SANDY SPRINGS
GEORGIA

P&Z STAFF REPORT

Case: **V16-0101 – 965 Landmark Drive**

Case: **V16-0145 –885 N. Island Drive**

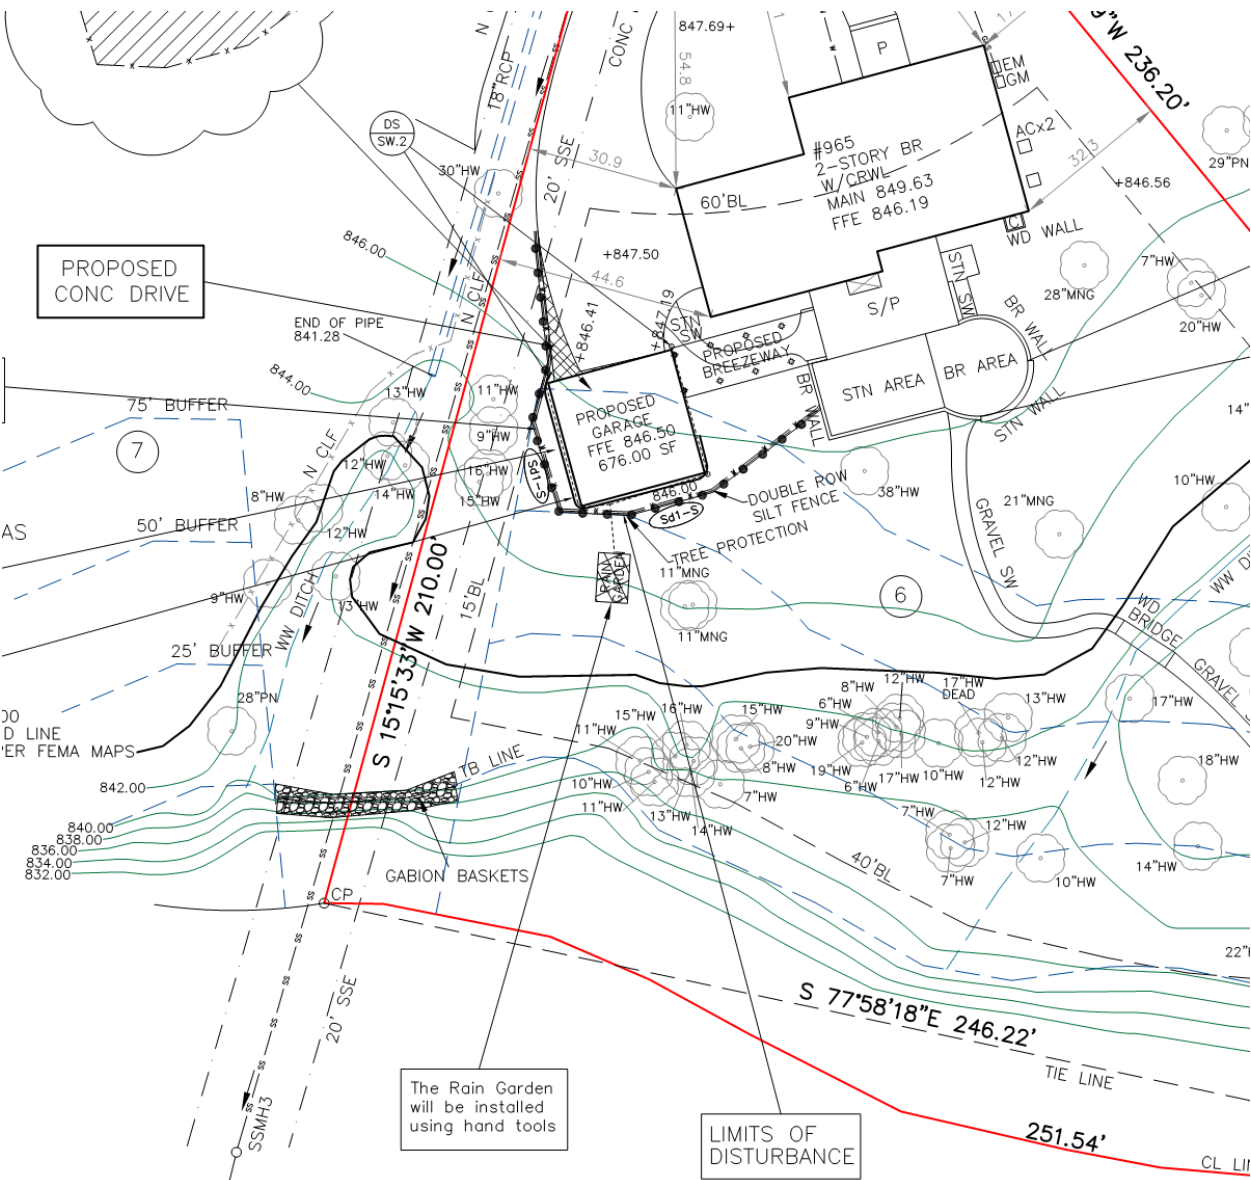
At the October 13th Board of Appeals hearing, the Board unanimously voted to grant the Applicant's request for a two-month deferral in order to allow time for the variance petition to be updated to include the findings of the gabion basket and the associated nullified buffer. The Applicant has resurveyed the property and has submitted a site plan that accurately represents the existing conditions. There is no change to Staff's findings or recommendations, only a slight adjustment to recommended condition of approval #2 which requires the Applicant to restore the Natural Vegetative Buffer in the area behind the proposed garage/in-law suite and Nancy Creek.

Since the time of the two-month deferral unanimously granted by the BOA at the October 13th hearing, the Applicant has provided a site plan updated with the gabion basket and the nullified stream buffer area drawn perpendicular from the stream. The terminated buffer area does NOT affect the proposed garage/in-law suite, but is directly adjacent to it to the west. No other new information has been provided to alter Staff's opinion regarding its recommendation or recommended conditions of approval, with the slight exception that Staff recommended condition #2 specifically states that replanting of the Natural Vegetative Buffer will not be required in area perpendicular to the stream behind the gabion basket.

- A. Stepanov for Joy and William Ordway on 10/18/16 and received by the Department of Community Development by 11/2/2016.
2. The 50-foot Natural Vegetative Buffer be restored in the area between the proposed garage and the stream up to but not encroaching into the terminated buffer area perpendicular to the gabion basket, according to the following requirements:

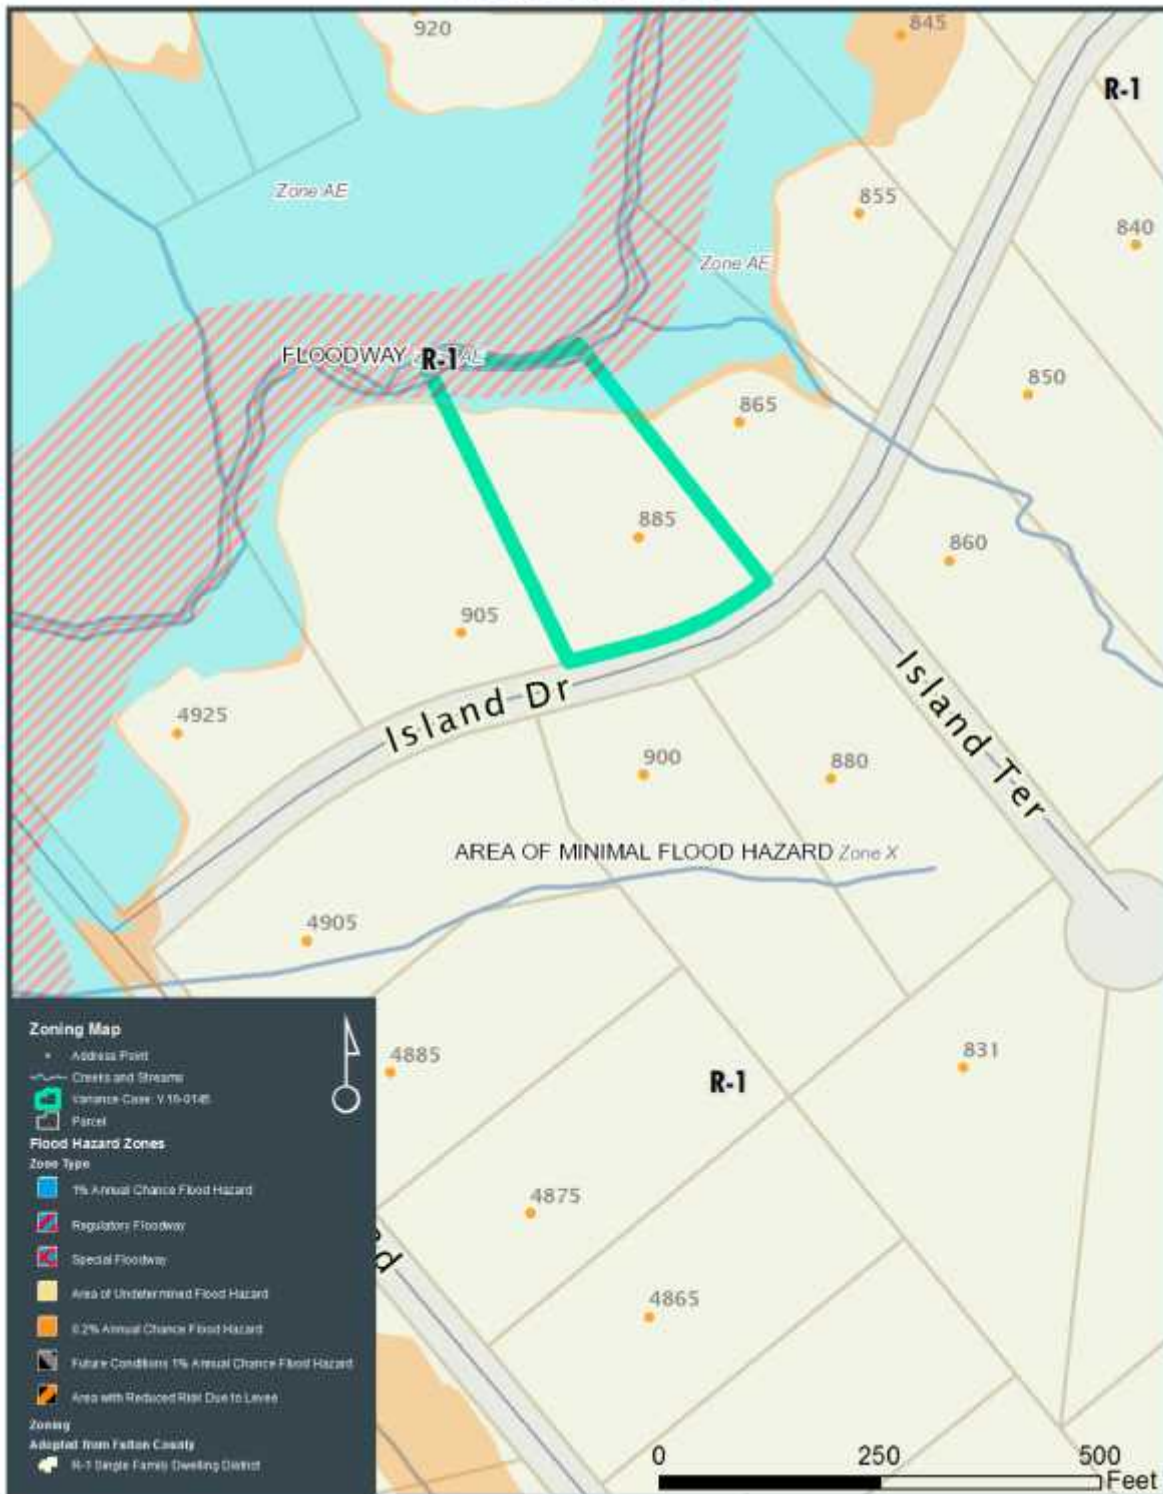
Finding: The applicant is proposing to remove an existing residence and redevelop the property with a new single-family home and accessory uses. The proposed detached garage would encroach 10 feet into the required 25-foot side yard setback. The submitted letter of intent indicates that there are several land features including trees, granite outcroppings, grade and a stream that constrain the site to best optimize the house location and associated accessory uses. The applicant's plan is to utilize the existing driveway in order to save a mix of trees including magnolia and crabapple trees that line the driveway. It is also noted in the letter of intent, that moving the home towards the east property line, where the topography decreases, may result in the removal of a specimen tree and create a larger basement wall, which would be unsightly and not desirable. Constructing the residence, detached garage or pool further north on the site infringes on significant slope, stream buffers and the granite outcroppings. In order to maintain the proposed home location and auto court design, it was decided that the garage must be located 10 feet into the side yard setback. Although these land features exist, the property is large enough and shaped in a manner that would accommodate redevelopment of the site without a variance. The applicant's proposed development of the site and desired property design are not consistent with the variance considerations. The auto court is large and there would be ample space to construct a detached garage in this location. The space to meet required setbacks is supported by the existing home, which currently meets the setback requirements. This would suggest that extraordinary circumstances due to size, shape or topography do not exist. In light of this, the application of the zoning ordinance does not create a hardship and therefore staff does not support approval of

1. To allow the proposed two-car garage to encroach 10 feet into the required 25-foot side yard setback, which shall include plantings, as shown on the submitted site plan dated October 18, 2016, and received by the Department of Community Development on October 21, 2016.
2. Minor revisions of the submitted site plan, as determined by the Department of Community Development, may be reviewed and approved by Staff. Any revision shall not include further encroachment of the use or structure.
3. Submit an as-built survey of the two-car garage to the Department of Community Development prior to the issuance of a certificate of occupancy.
